ADDENDUM NO. 1 TO 14-0053-4

FOR: JENNIFER ROSS SOCCER COMPLEX DROP-OFF AND PARKING

Jennifer Ross Parking and Drop-Off Addendum #1

LAYOUT AND STRIPING PLAN

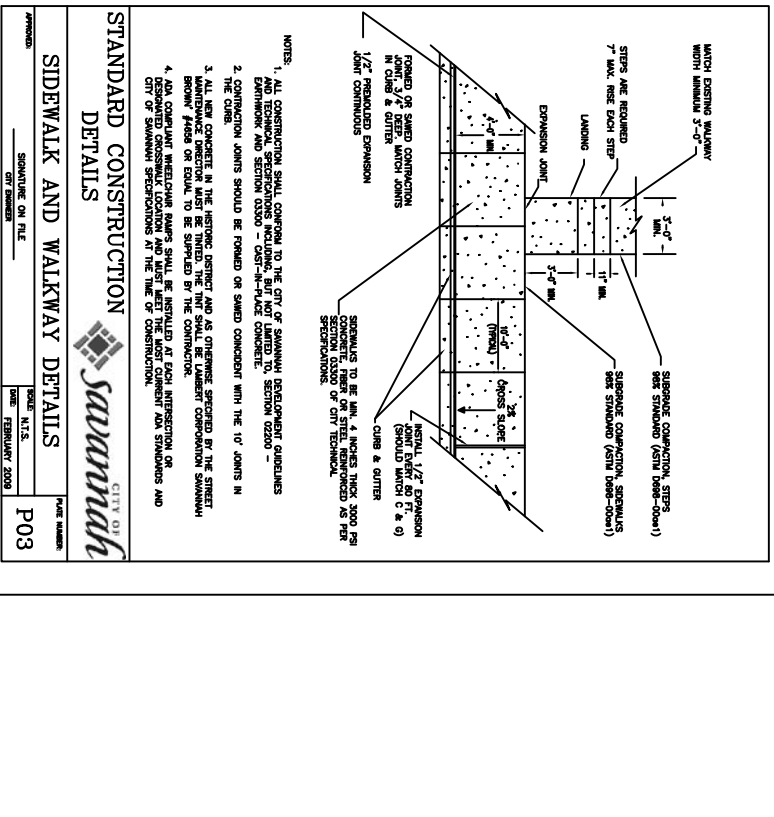
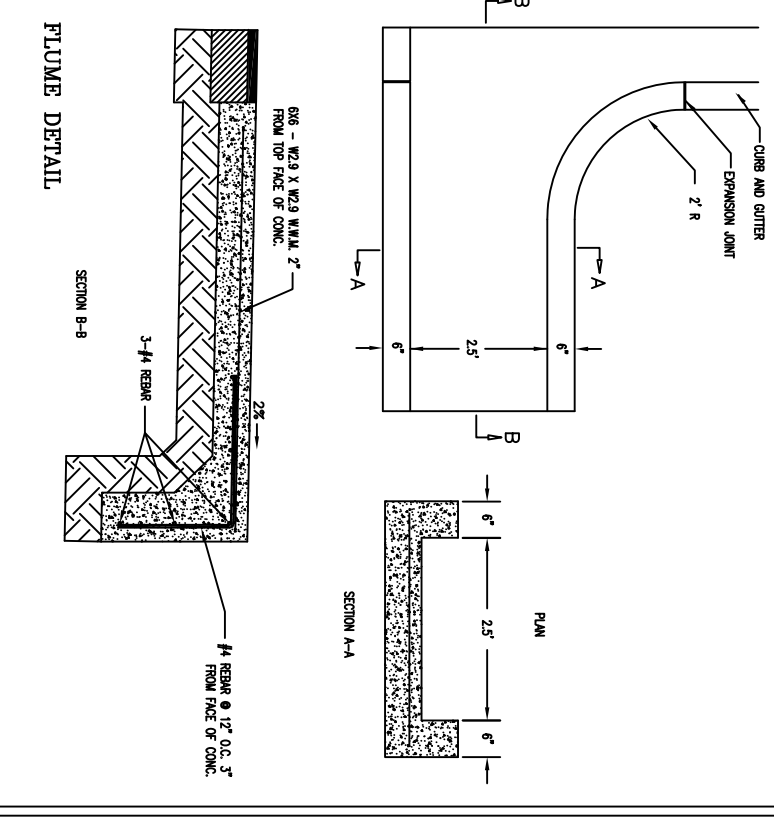
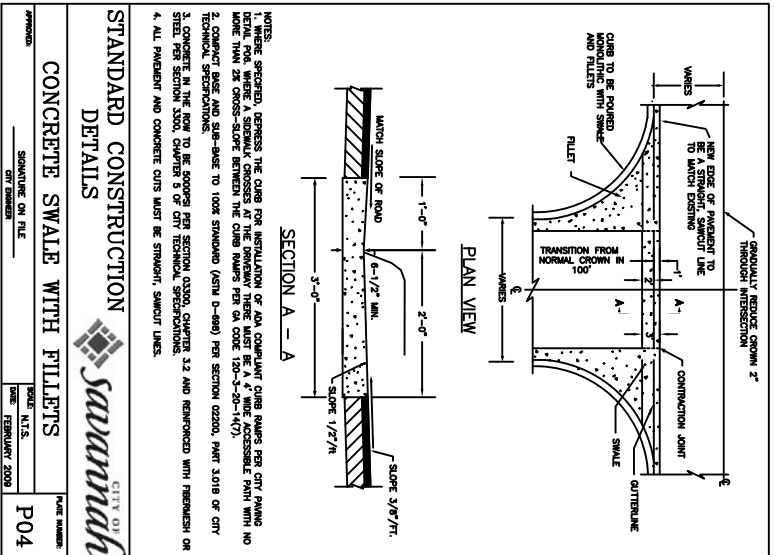
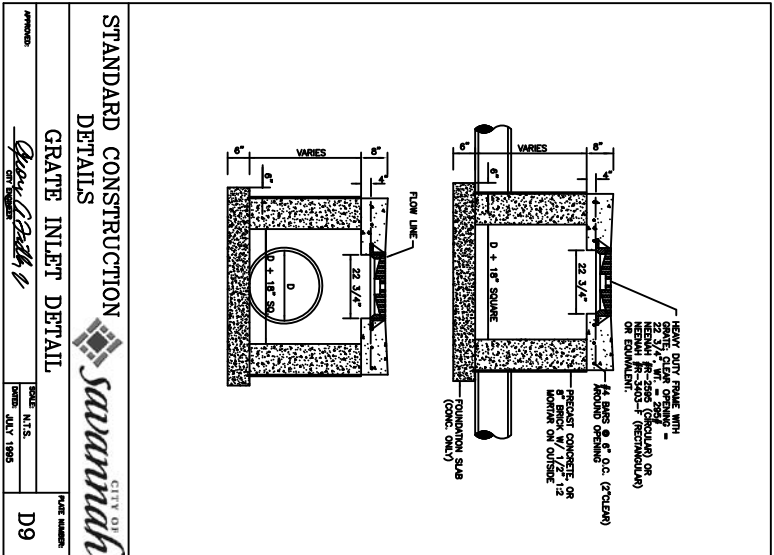
- 1. Responses to questions received. (1 sheet)**
- 2. Replace current Bid Sheet with the attached REVISED Bid Sheet. (1 sheet)**
- 3. Replace current Plan Sheets with the attached REVISED Plan Sheets (4 sheets):**
 - Layout and Striping (Sheet # 3)**
 - Paving Grading & Drainage (Sheet #4)**
 - Construction Details (Sheet # 13)**
 - Construction Details (Sheet # 14)**
